PERMIT 04-316231

**ON-SITE SEWAGE DISPOSAL SYSTEM
 HOWARD COUNTY HEALTH DEPARTMENT
 BUREAU OF ENVIRONMENTAL HEALTH**

ADDRESS: 2425 Duvall Road (Tenant House) PROPERTY OWNER: Covered Bridge Farm LLC

SITE INSPECTION SHEET

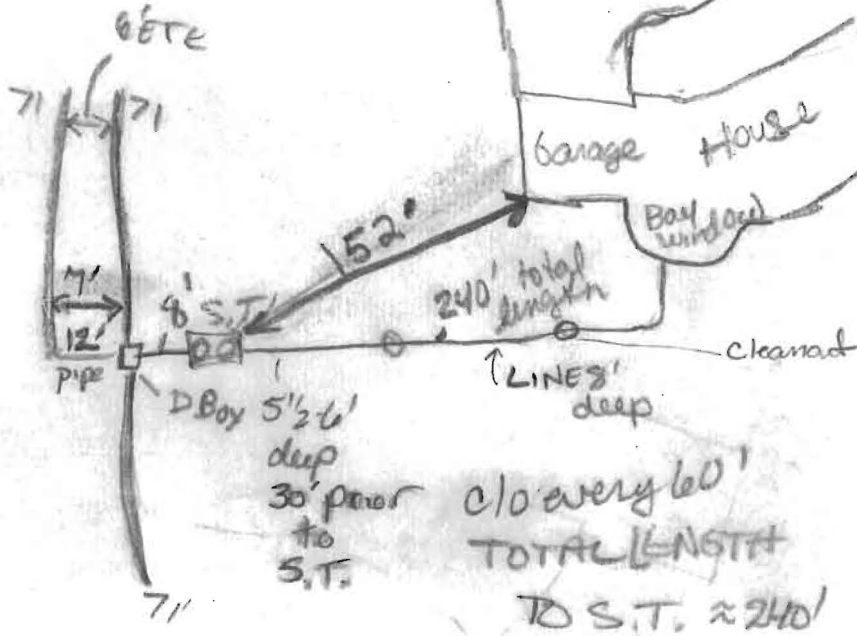
SEPTIC TANK CAPACITY (GALLONS): ~~1250~~ 1500 OUTLET BAFFLE FILTER REQUIRED

LINEAR FEET OF TRENCH REQUIRED: ~~280~~ 210 (New spec)

PRE-CONSTRUCTION 1/4/05 - SRA stated contour accurate, Inst #3
70' trenches on contour (S) 1-11-05
 INSTALLATION 1-11-05 installed 30K to cover WELL LINE
INSP TO come... (KN)

LOCATION DIAGRAM

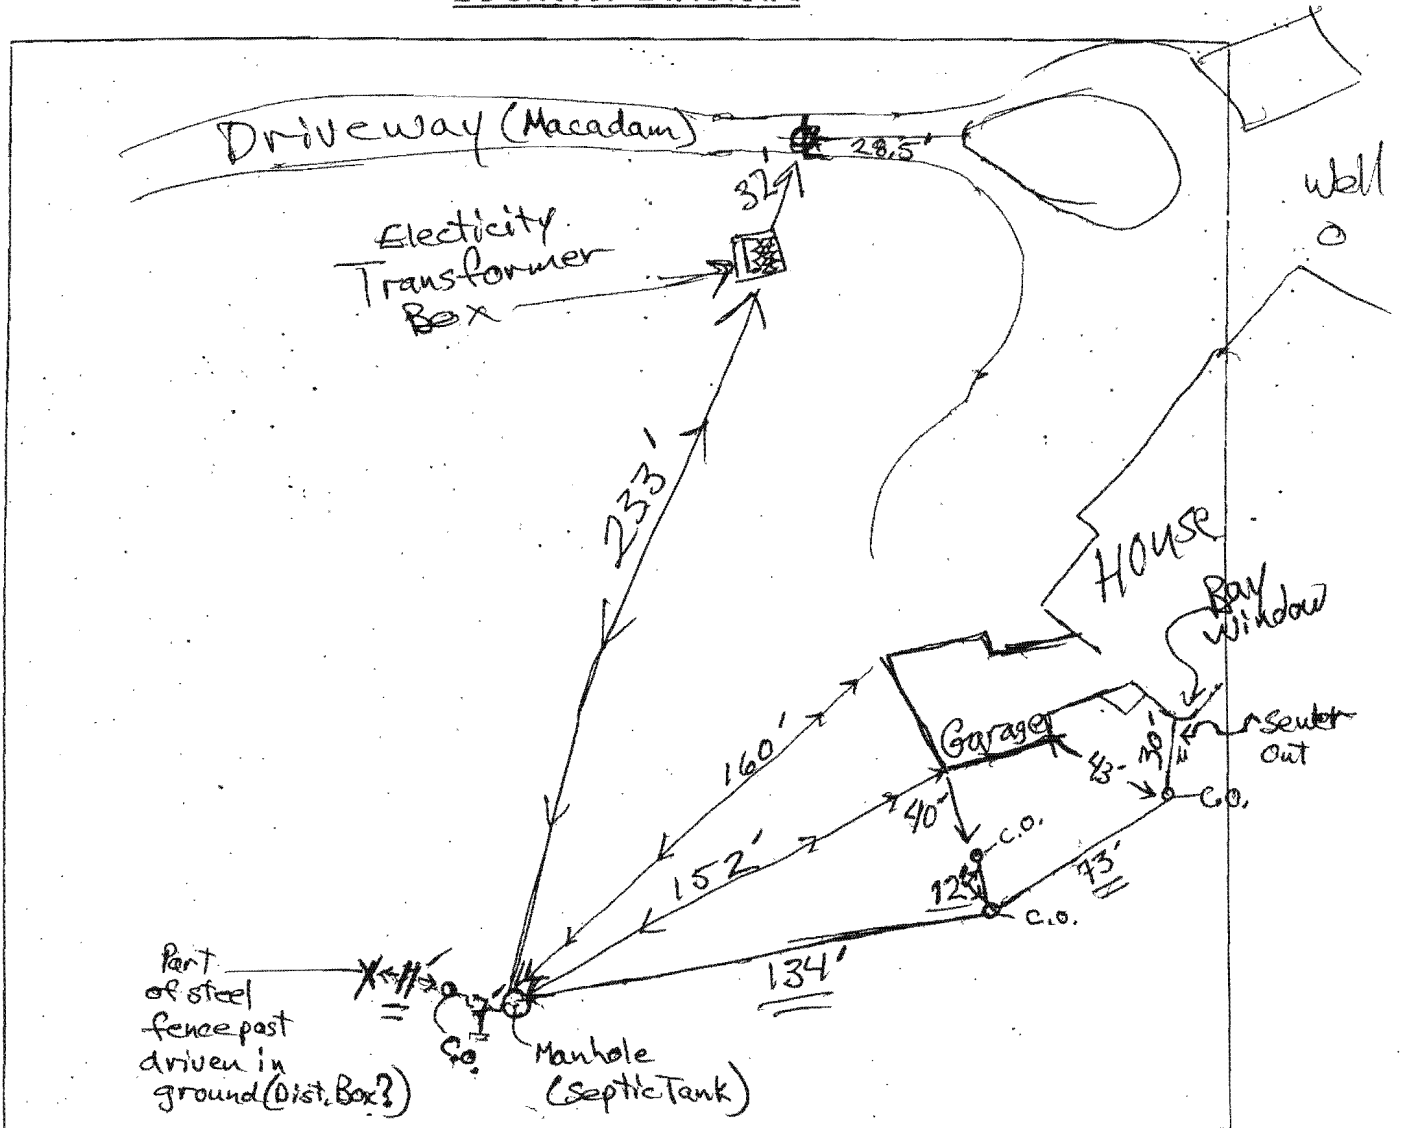
COMMENTS: Sketch of septic system line from residence to septic tank. Confirms distance and location of 'as built' drawing. feb 2/1/07
